April 4, 2024
Planning Commission
Regular Meeting
Information Packet

Discussion of the proposed Preliminary
Final plan for the Anderson Ranch
subdivision Phase 4E, located at
approximately Silver Spur Rd (East of
Anderson Ranch Phase 3).

Planning Staff Explanation and Recommendation: Discussion only for Anderson Ranch Phase 4E. Please note that the plat was labeled as a Preliminary Plat, and was noticed as such. However, it is a Final Plat, and has been reviewed as such.

ANDERSON RANCH PHASE 4E

DEEP WASH ROAD

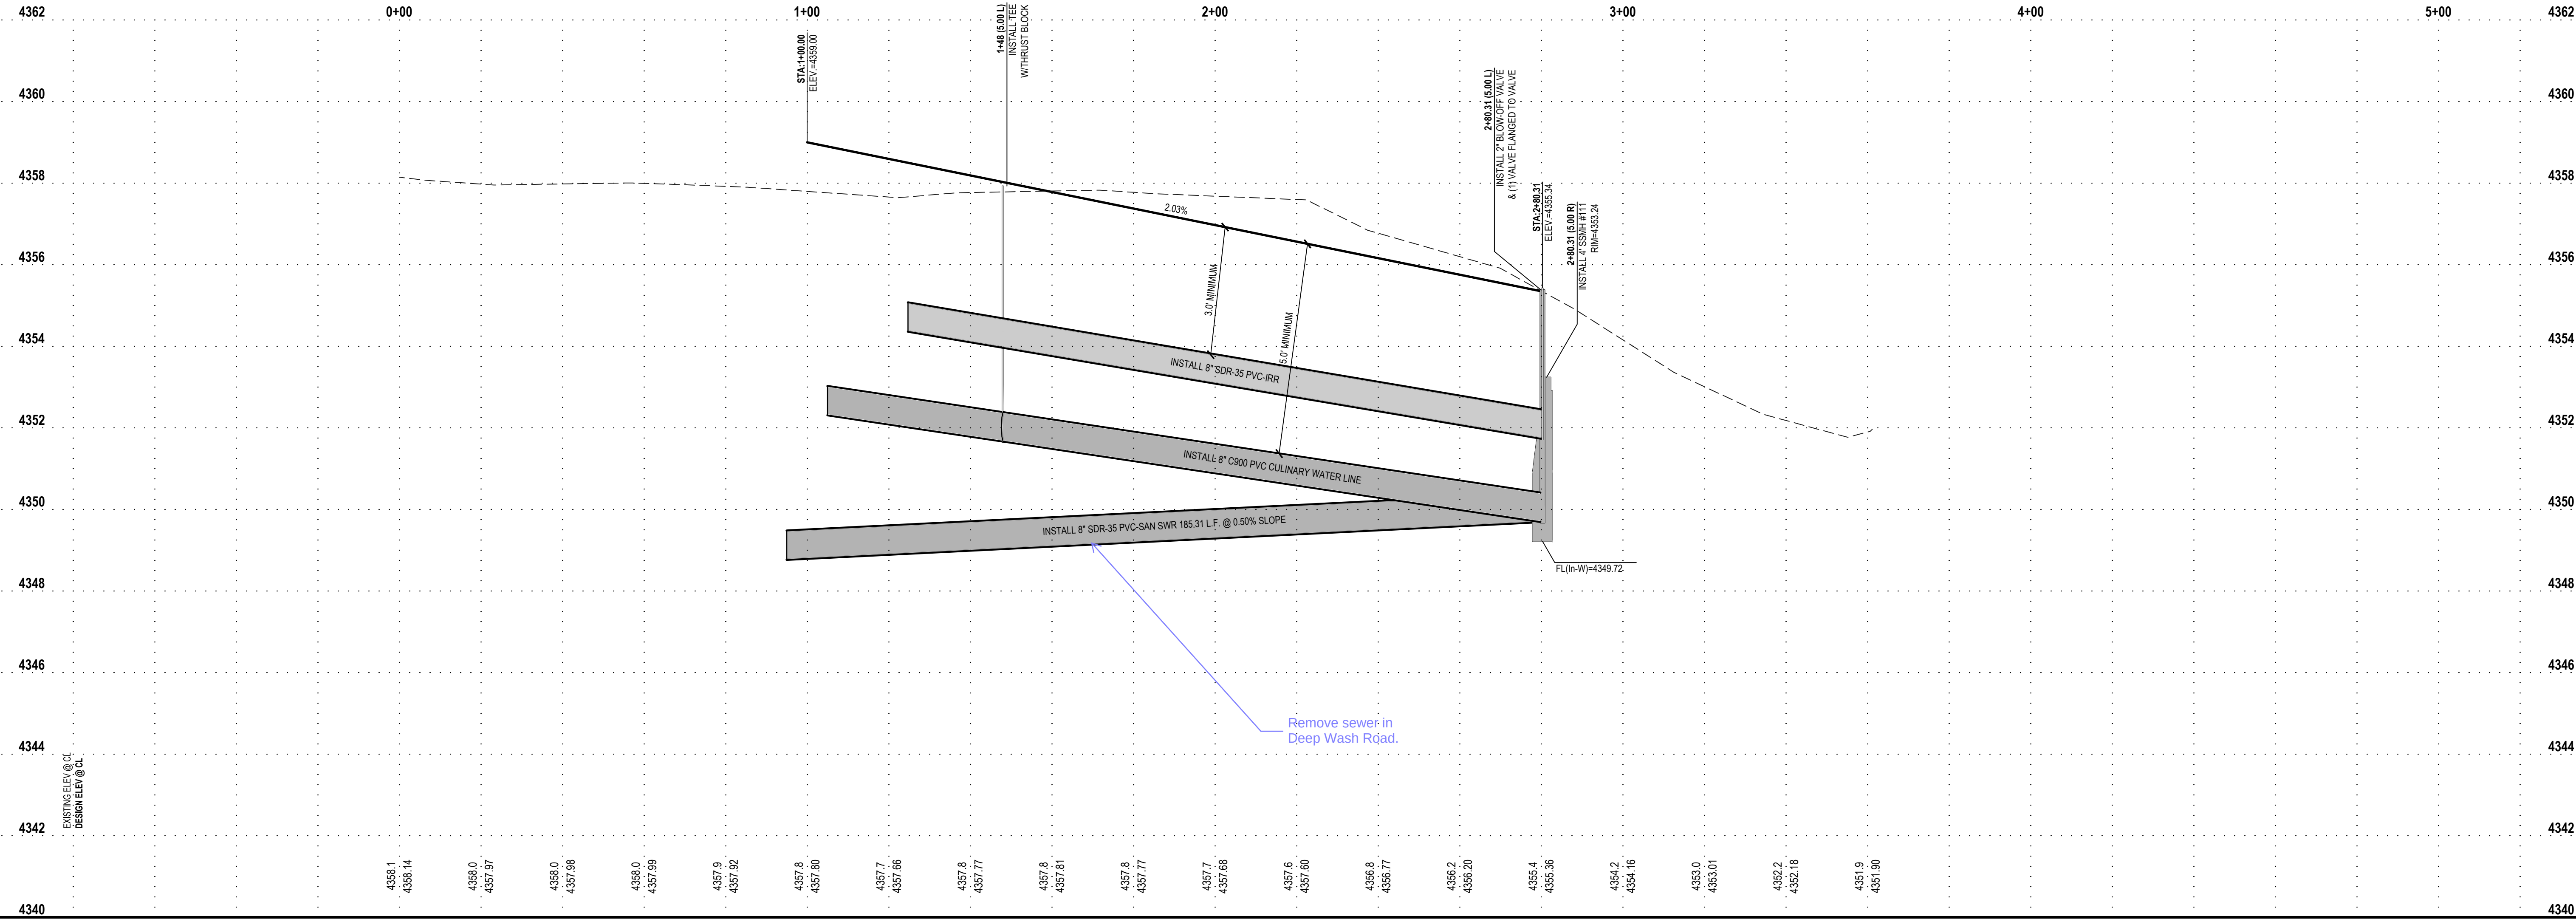
Gary: Twenty Wells may not design their street to drop down through this wash. the street profile needs to be coordinated with Twenty Wells and the utilities adjusted accordingly.

Gary: If a temporary turnaround will be required this grading will need to be revised to get the turnaround out of the wash.
This would be a good location for barriers at 150 feet back from the lip of curb of Gold Nugget.
